# UNITED STATES PATENT AND TRADEMARK OFFICE

APPLICATION NO.	FILING DATE	FIRST NAMED INVENTOR	ATTORNEY DOCKET NO.	CONFIRMATION NO.
10/767,350	01/30/2004	Ric Joranlien	246434US67	5239
22850	7590	11/22/2005		
OBLON, SPIVAK, MCCLELLAND, MAIER & NEUSTADT, P.C. 1940 DUKE STREET ALEXANDRIA, VA 22314			EXAMINER COOLEY, CHARLES E	
			ART UNIT	PAPER NUMBER
			1723	
DATE MAILED: 11/22/2005

## **NON-FINAL OFFICE ACTION**

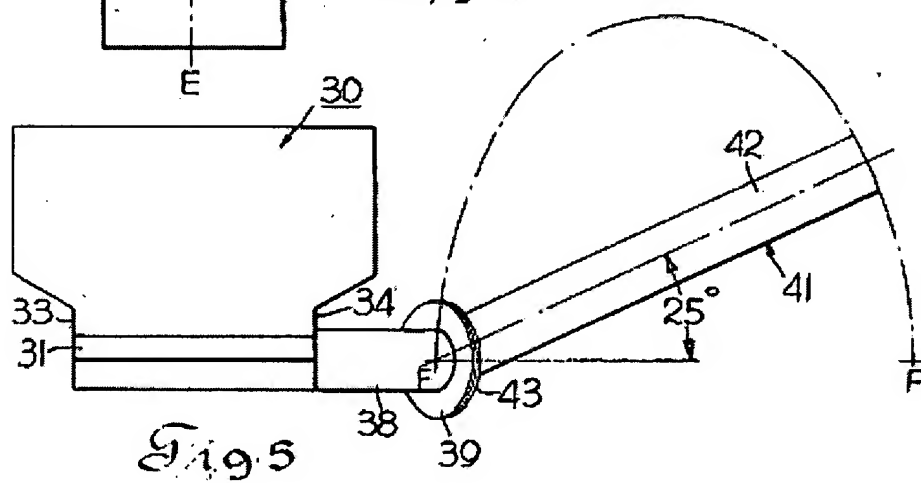
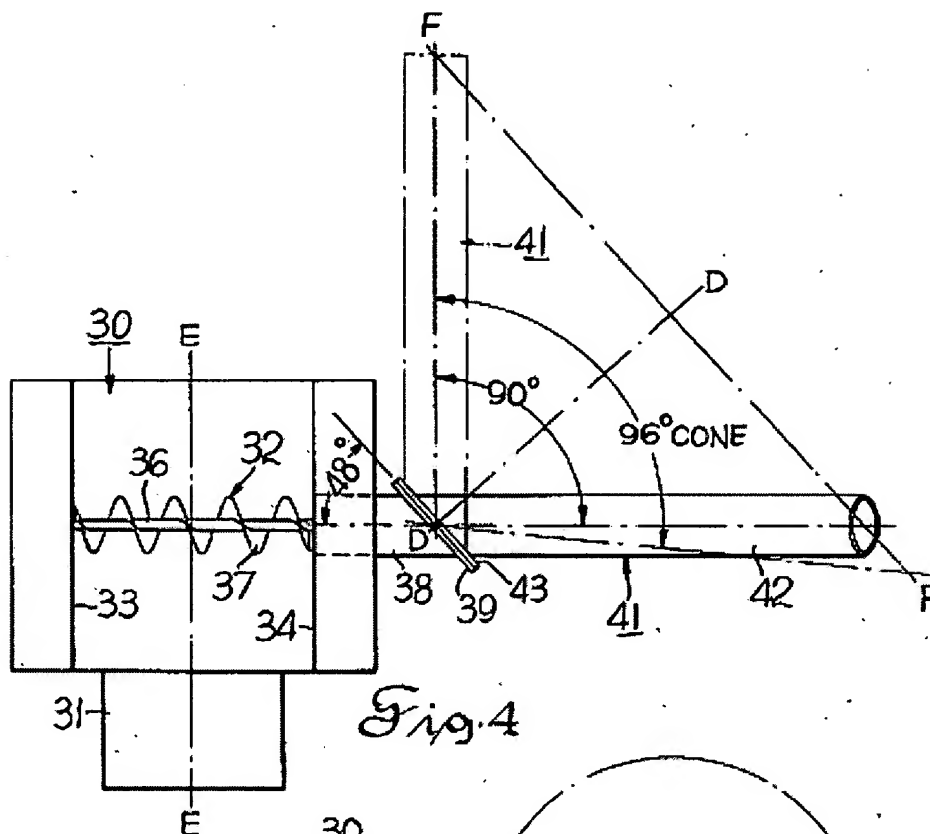
The patent to Boone discloses in Figs. 4-5 as seen below a rotatable auger assembly with cores 32 and 41 that are non-concentric and disposed at an adjustable angle with respect to each other within the recited ranges; and a plate type shim 39 and/or 43 facilitating the angular adjustment.

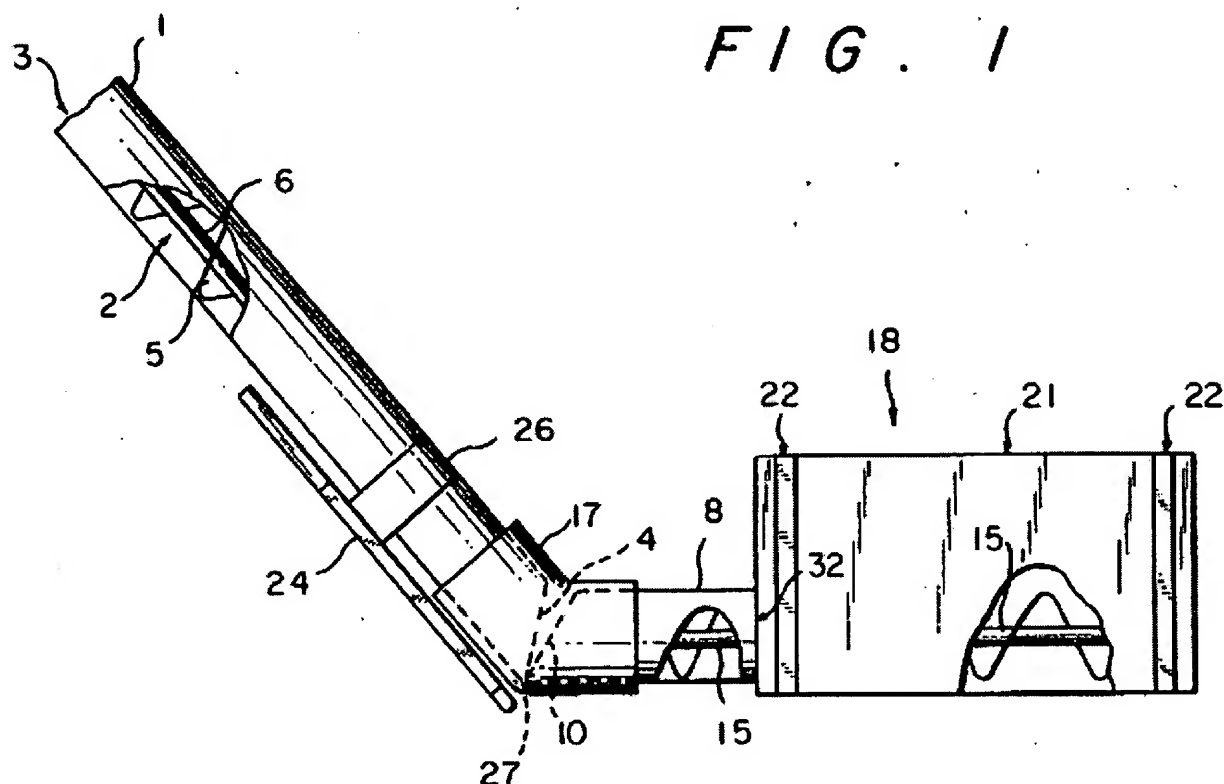
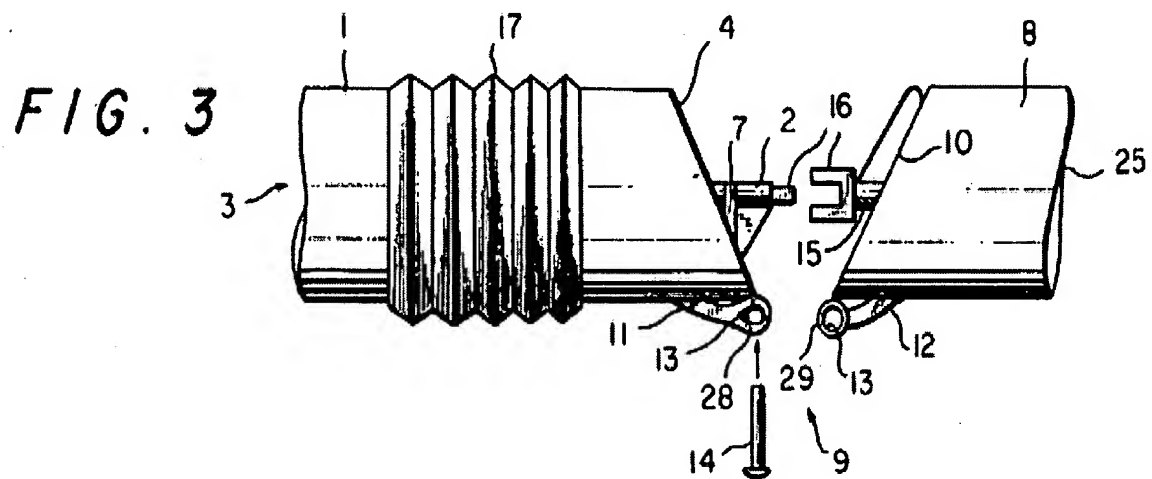
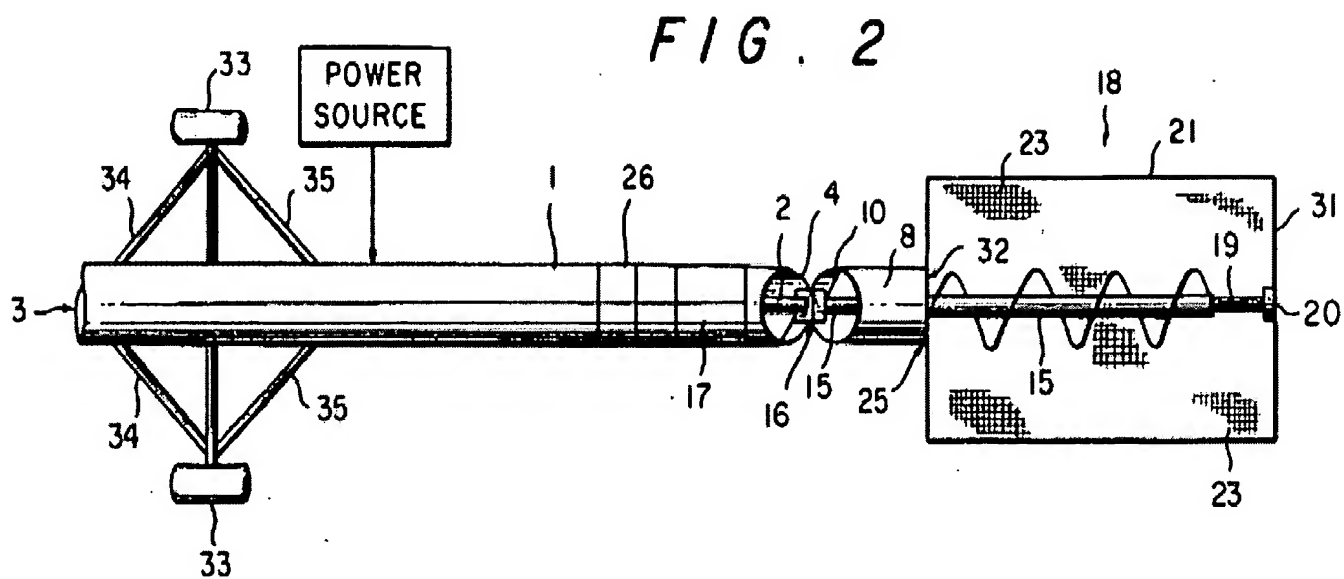
The patent to Stuckey discloses in Figs. 1-3 as seen below a rotatable auger assembly with cores 2 and 15 that are non-concentric and disposed at an adjustable angle with respect to each other within the recited ranges; and a plate type shim 16 facilitating the angular adjustment.

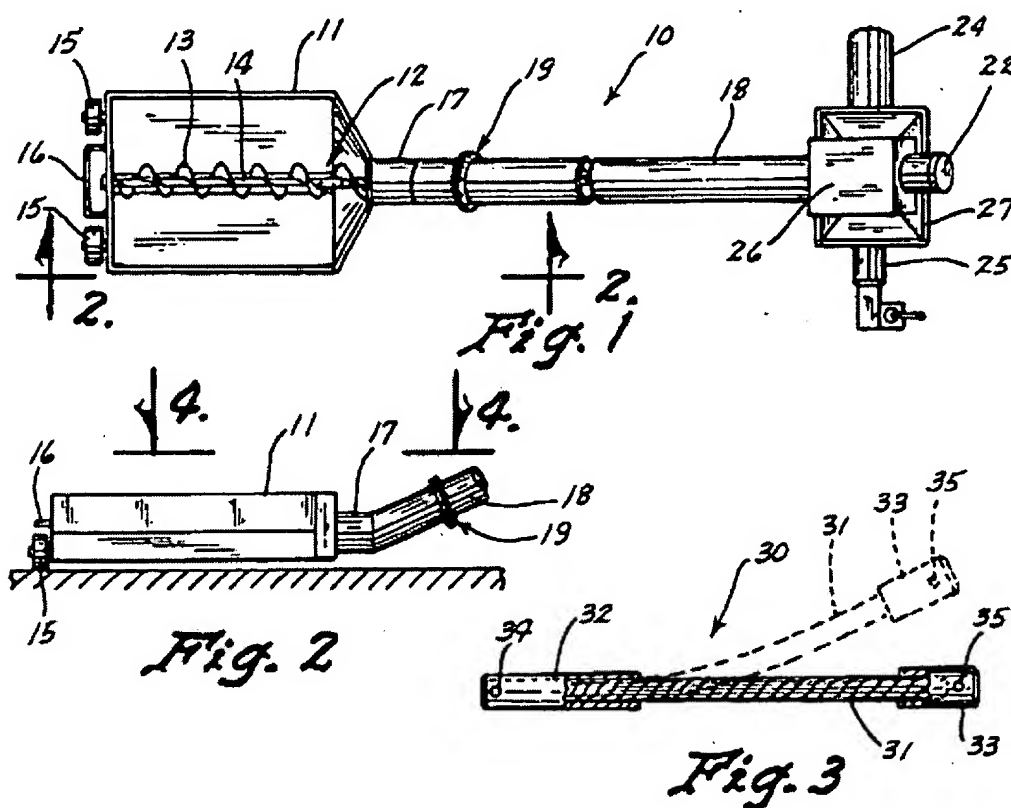
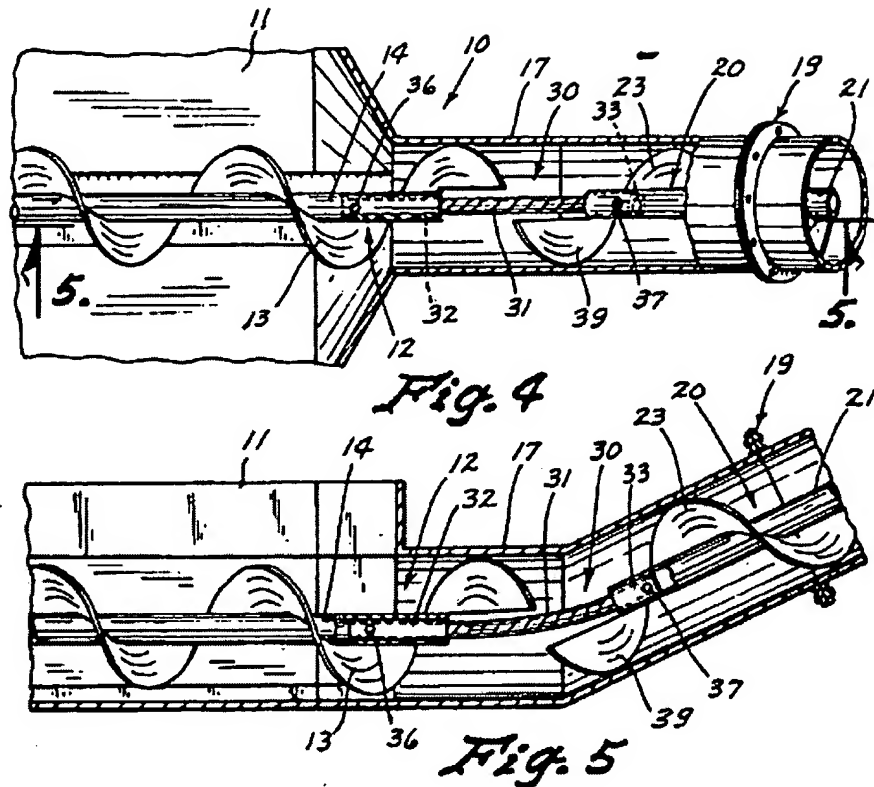
The patent to Barenthsen discloses in Figs. 1-5 as seen below a rotatable auger assembly with cores 14 and 20 that are non-concentric and disposed at an adjustable angle with respect to each other (Fig. 3) within the recited ranges.

**Fig. 1**

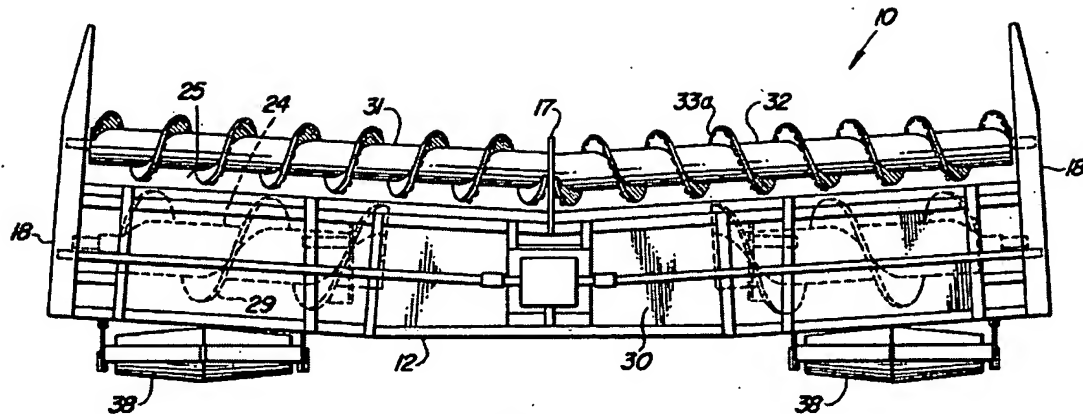
The patent to Lundahl et al. discloses in Fig. 1 as seen below a rotatable auger assembly with cores 31 and 32 that are non-concentric and disposed at an angle with respect to each other within the recited ranges.
